1. All locations and dimensions are approximate.
EXHIBIT NO. 3
APPLICATION NO.
A-1-FTB-05-053
GEORGIA PACIFIC CORP.
SITE PLANS (1 of 6)
ITACHMENT 3
N
0
200
400
800
Feet
FIGURE D-2
FOUNDATION REMOVAL OVERVIEW
Georgia-Pacific California Wood Products Manufacturing Facility
90 West Redwood Avenue, Fort Bragg, California
Project No. 16017.05
Map File 1601706-005
Drawn By AAC
Prepared By JRS
Reviewed By MAA
Revision/Date
Scale
Acton Mickelson Environmental, Inc.
Consulting Scientists, Engineers, and Geologists
5175 Hillsdale Circle #100
El Dorado Hills, California 95762

Georgia-Pacific Corporation (G-P) has authorized Acton • Mickelson • Environmental, Inc. (AME) to prepare Addendum #2 to the *Work Plan for Foundation Removal, Additional Investigation, and Interim Remedial Measures* dated March 21, 2005 (Work Plan) for the Georgia-Pacific California Wood Products Manufacturing Facility located at 90 West Redwood Avenue in Fort Bragg, California (site; Figure 1). Addendum #2 is submitted to supplement a July 18, 2005 response to review comments made in a July 1, 2005 letter from the Regional Water Quality Control Board – North Coast Region (RWQCB) regarding the Work Plan and Addendum da

FIGURE 3

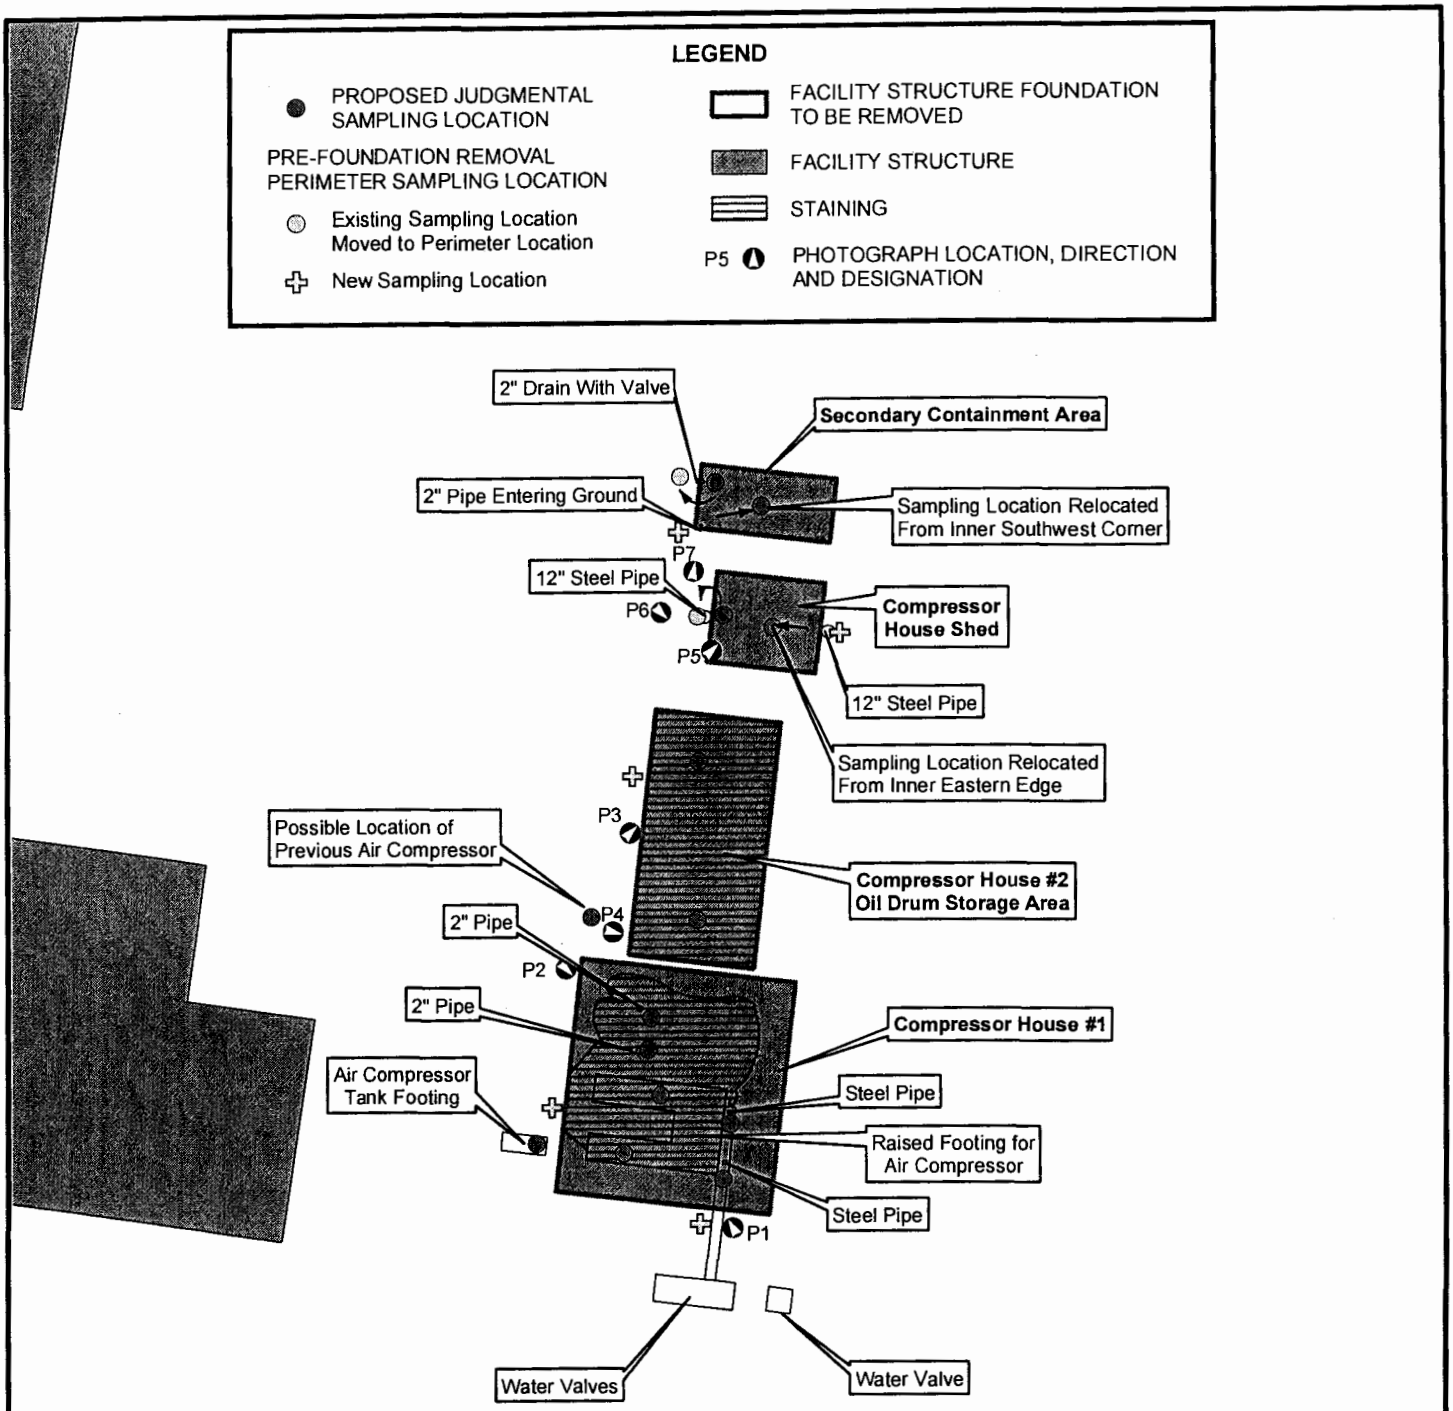
Samples will be collected from two locations at the Compressor House #1 foundation perimeter prior to foundation removal (Revised Figure 3). These two sample locations were not previously proposed in the Work Plan. The north, south, and east sides of the foundation are comprised of a wall, which does not extend along the west side. One sample will be collected at the west side of the foundation. The other sample will be collected at the south foundation wall where a pipe exits the foundation. Sample analysis and other foundation sampling will be as specified in the Work Plan.

A sample will be collected from one location at the Compressor House #2 foundation perimeter prior to foundation removal (Revised Figure 3). This location was not previously proposed in the Work Plan. The north, south, and east sides of the foundation are comprised of a wall, which does not extend along the west side. The sample will be collected at the west side of the foundation perimeter. Sample analysis and other foundation sampling will be as specified in the Work Plan.

Samples will be collected from two locations at the Compressor House Shed foundation perimeter prior to foundation removal (Revised Figure 3). These two samples will be collected at steel pipes off the east and west sides of the foundation. One of the samples will be accomplished by shifting the location of a previously proposed sample from within the foundation footprint to outside the foundation footprint. Sampling at the other location will be accomplished with a sample not previously recommended in the Work Plan. The location of one of the samples recommended in the Work Plan will be shifted to the center of the foundation footprint. Sample analysis will be as specified in the Work Plan.

Samples will be collected at two locations at the Secondary Containment Area foundation perimeter prior to foundation removal (Revised Figure 3). These two samples will be collected at a drain and a pipe outside the west side of the foundation. The foundation includes concrete walls on all four sides. One of the samples will be accomplished by shifting the location of a previously proposed sample from within the foundation footprint to outside the foundation footprint. Sampling at the other location will be accomplished with a sample not previously recommended in the Work Plan. The location of one of the samples recommended in the Work Plan will be shifted to the center of the foundation footprint. No indicators of potential hazardous-materials discharges were observed within the foundation. Sample analysis will be as specified in the Work Plan.

FIGURE 5

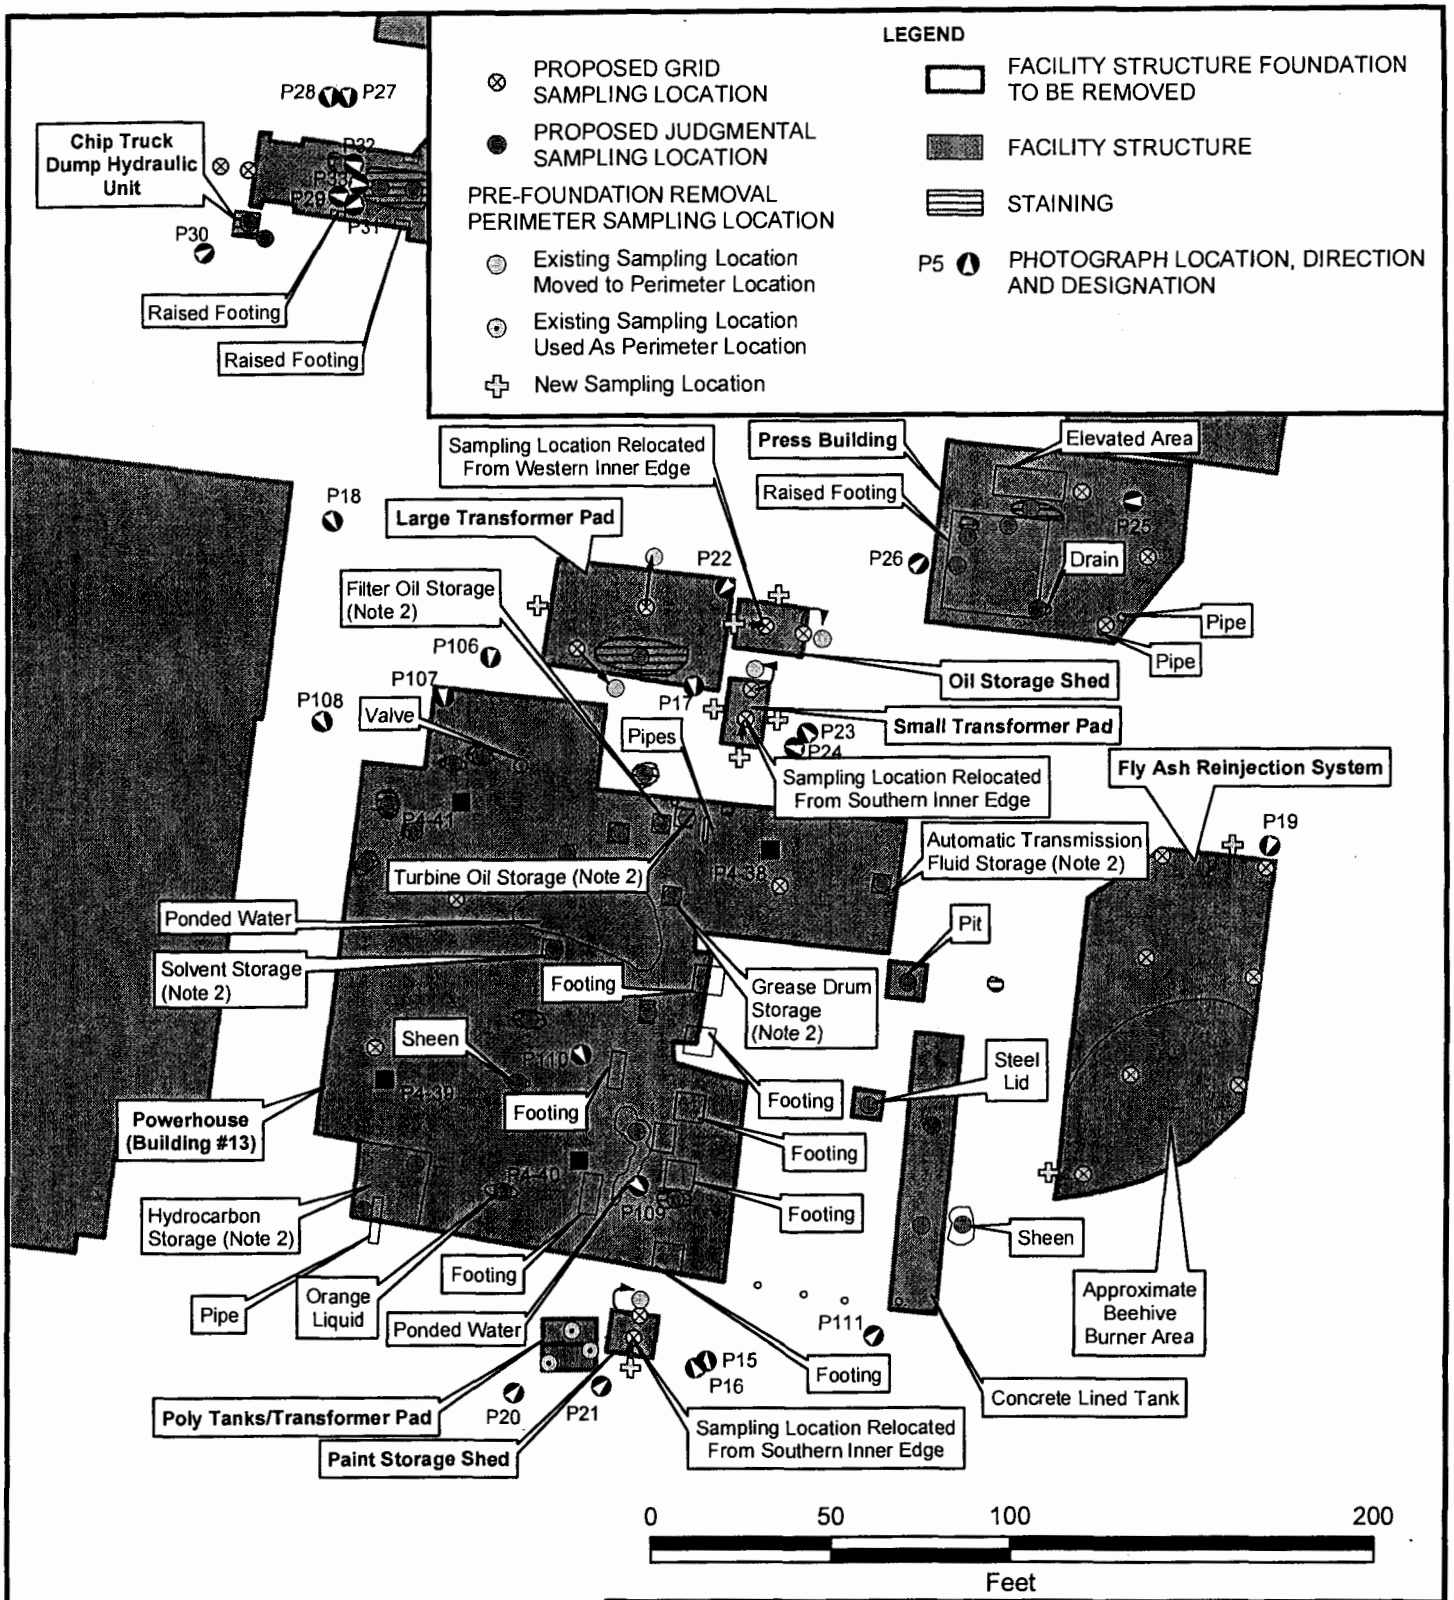
Samples will be collected from two locations at the foundation perimeter prior to foundation removal (Revised Figure 5). These two locations were not previously proposed in the Work Plan. The east and south walls of the foundation are formed by the berm/retaining wall of the Log Pond. The northwest side of the foundation was comprised of a wall also. One of the additional

Samples will be collected from 10 locations at the foundation perimeters prior to foundation removal (Revised Figure 5). Sampling at four of these locations will be accomplished by shifting the location of previously proposed samples from within the foundation footprints to outside the foundation footprints. These four samples were at grid locations where no indicators of potential hazardous-materials discharges were observed. Sampling at the other six perimeter locations will be accomplished with six additional samples not previously proposed in the Work Plan. The locations of two of the samples recommended in the Work Plan will be shifted to the center of the foundation footprints. The foundations do not include sidewalls. Sample analysis and other foundation sampling will be as specified in the Work Plan.

Samples will be collected from three locations prior to Poly Tanks/Transformer Pad foundation removal (Revised Figure 5). The Poly Tanks/Transformer Pad was comprised of two concrete supports and was not an actual pad. The locations of the three samples will remain as proposed in the Work Plan, which were outside the footprint of the concrete supports. Sample analysis will be as specified in the Work Plan.

Samples will be collected from two locations at the Paint Storage Shed foundation perimeter prior to foundation removal (Revised Figure 5). One of the samples will be accomplished by shifting the location of a previously proposed sample from within the foundation footprint to outside the foundation footprint. Sampling at the other location will be accomplished with a sample not previously recommended in the Work Plan. The location of one of the samples recommended in the Work Plan will be shifted to the center of the foundation footprint. No indicators of potential hazardous-materials discharges were observed within the Paint Storage Shed. The Paint Storage Shed was comprised of a concrete floor and concrete walls on the south, east, and west sides with a door on the north side. Sample analysis will be as specified in the Work Plan.

FIGURE 12

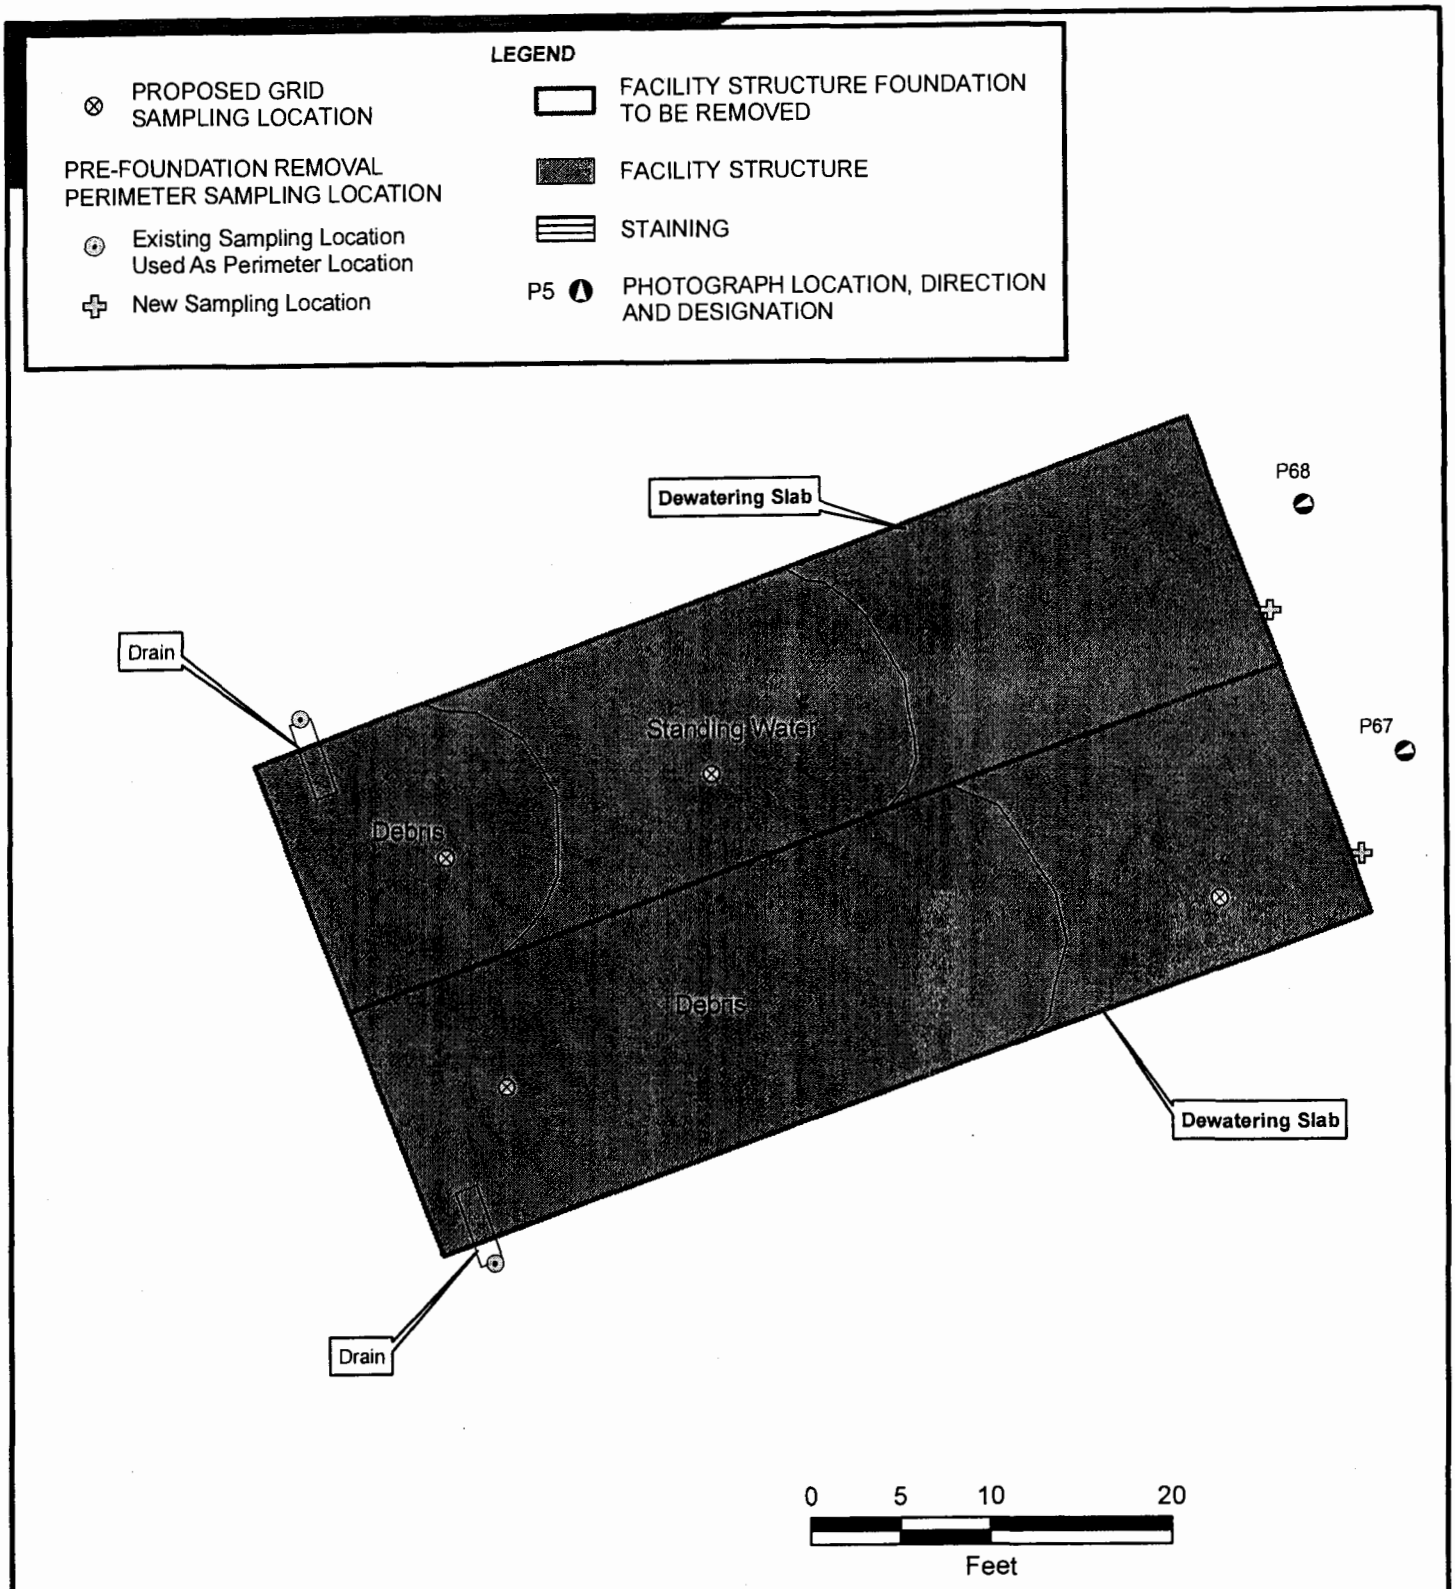
Samples will be collected from four locations at the foundation perimeter prior to foundation removal. Two of these locations were previously proposed in the Work Plan at the outside terminus of two drains at the northwest and southwest corners of the slabs (Revised Figure 12). Two additional samples will be collected at the east/southeast end of the slabs where no foundation wall is present. The north, south, and west sides of the Dewatering Slabs consist of a

FIGURE 14

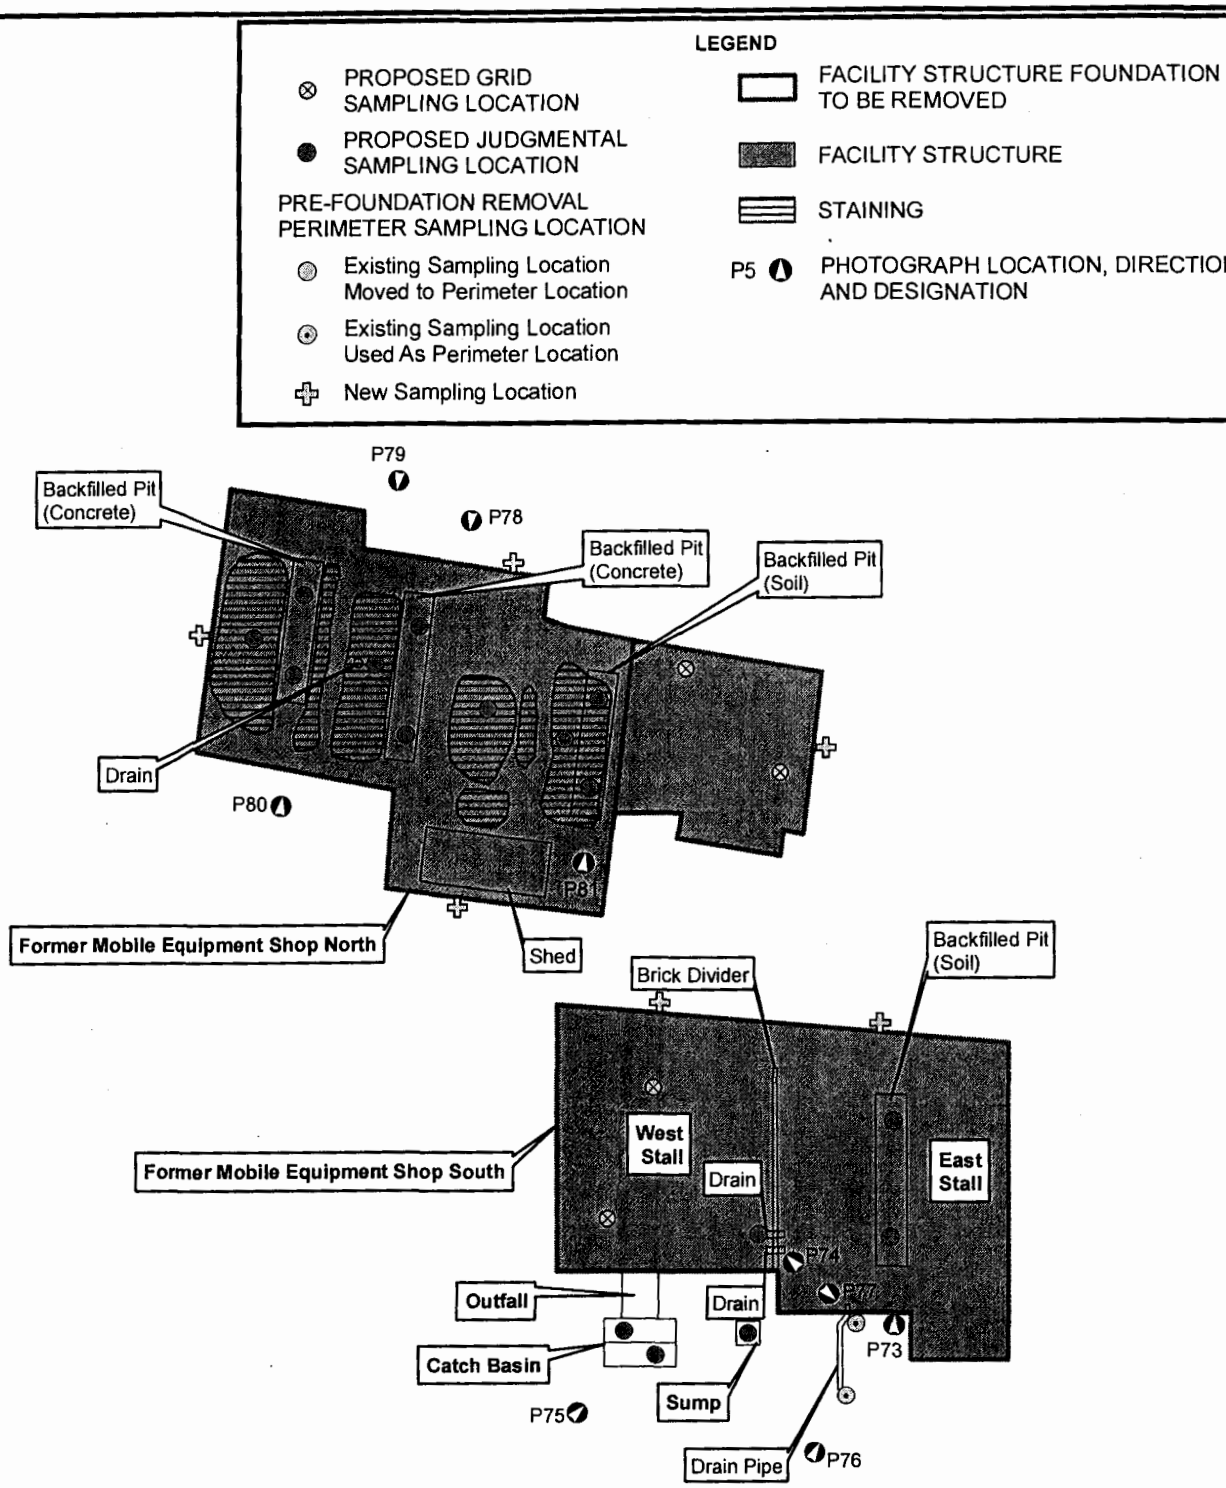
Samples will be collected from eight locations at the foundation perimeters prior to foundation removal (Revised Figure 14). Two of these samples adjacent to a drain pipe on the south side of Former Mobile Equipment Shop South were previously proposed in the Work Plan, whereas the other six were not. The Former Mobile Equipment Shop North foundation did not include sidewalls. The Former Mobile Equipment Shop South foundation included walls on the south, east, and west sides, but not on the north side. Two of the samples will be collected off the north side of that foundation. Sample analysis and other foundation sampling will be as specified in the Work Plan.
